Preliminary Consultation MONTGOMERY COUNTY HISTORIC PRESERVATION COMMISSION STAFF REPORT

Address: 10221 Menlo Ave., Silver Spring Meeting Date: 9/17/2025

Proposal: Construction of New Single-Family House and grading and hardscape alterations

Figure 3: Proposed right (south) elevation option showing three windows.

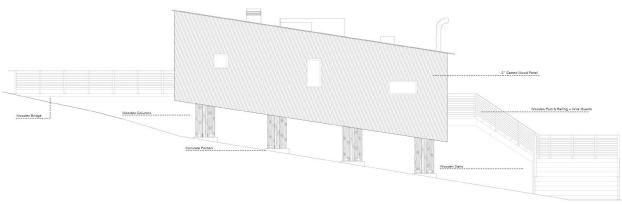
The initial design called for a blank elevation on the south (right) elevation. Staff provided preliminary comments to the applicant that because this elevation is one of the two that faces into the historic district, a treatment that broke up the long uninterrupted plane was warranted. The applicant provided three design revisions that introduce some fenestration to this elevation (the right elevation option with three windows and angled wood siding is shown in *Figure 3*, below). The rear (east) and left (north) elevations face out of the historic district and are not at all visible from the public right-of-way (*Figures 4* and *5*). Both of these elevations are largely glazed, with evenly spaced windows at the rear and groups of glass doors along the right elevation. An exterior stair runs along the northern elevation that provides access to the rear yard.

Figure 4: Proposed left (north) elevation.

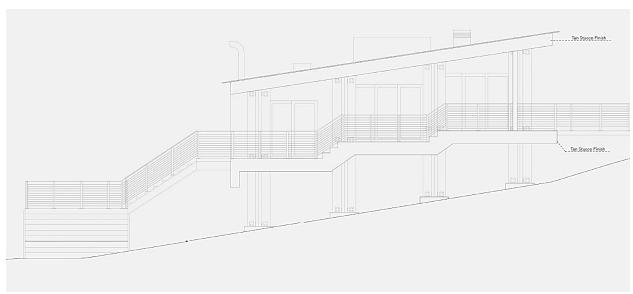
Staff, however, has several questions for the HPC regarding the overall compatibility of the house within the larger Capitol View Park Historic District.

As with the previous design, Staff finds the proposed design, though distinctly contemporary, will likely not detract from the character of the surrounding district. The roof form, window size and scale are all intended to stand apart from the historic buildings and historic building styles found throughout the historic district. By utilizing the pent roof that aligns with the lot slope, the overall mass of the house is

Without trying to replicate features of historic architecture, Staff finds that more could be done utilizing either siding material and/or pattern or window arrangement to help the house be compatible with the surrounding historic district.

Figure 5: Proposed rear elevation.

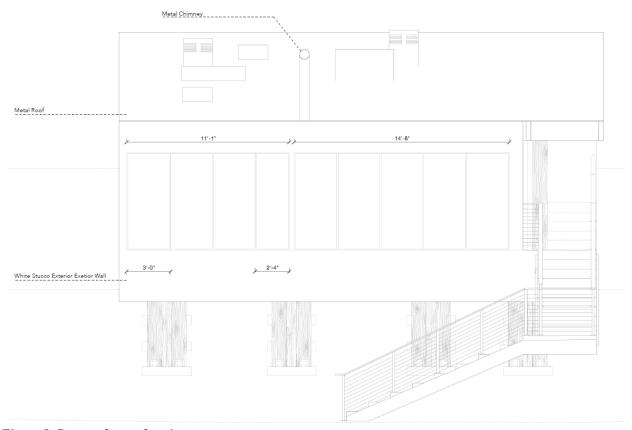
As stated earlier, the proposal does not identify most materials proposed for the new house. As this is contemporary construction, Staff finds that a wide variety of materials would be appropriate. Staff finds that the natural stucco finish shown in several of the renderings would be acceptable, as would wood clapboards. Depending on the configuration, Staff believes several fiber cement products would be appropriate as well. All of the windows shown in the renderings are single-light fixed or casement windows in punched openings. Staff finds that wood or metal windows would be compatible with the character of the design and the surrounding district. Due to the shiny finish, Staff has reservations about the appropriateness of many vinyl or fiberglass products but is open to reviewing material samples. Because the low-sloping pent roof will not be at all visible, Staff finds that a variety of metal, or membrane roofs would be acceptable. The roof slope appears to be too low for most asphalt or composite shingles. Finally, based on the guidance in the HPC's adopted policy on porch and deck materials, Staff finds that both natural wood and most synthetic products would be appropriate in this location.

At the rear of the house, the applicant proposes constructing a large set of wooden stairs, described in the plans as 'Amphitheater Steps.' Dimensions of these stairs and fine-grained material specifications were not provided; however, Staff finds that the feature as rendered is generally compatible with the character of the site and will note be visible from the public right-of-way. As the case with the bridge in front of the house, both natural and synthetic products would be appropriate for this feature. Staff encourages refinement of this feature and more detailed specifications before submitting for the final HAWP.

As a practical matter, Staff encourages a discussion of the treatment of the area under the house. Because this space will be in shade, it will be difficult to impossible to grow any plants in this area. To avoid extensive erosion, some measures must be taken. Staff encourages a further fleshing out of this space to protection the site slope and reduce erosion. This issue will need to be addressed as part of the required Sediment Control Permit, which requires a drainage plan for permitting, and Staff encourages the applicant to begin consultations with civil engineering firms to address these issues sooner rather than later (additional discussion of hardscaping and landscaping alterations are discussed below). A preliminary sediment control plan will be required for review with the final HAWP application.
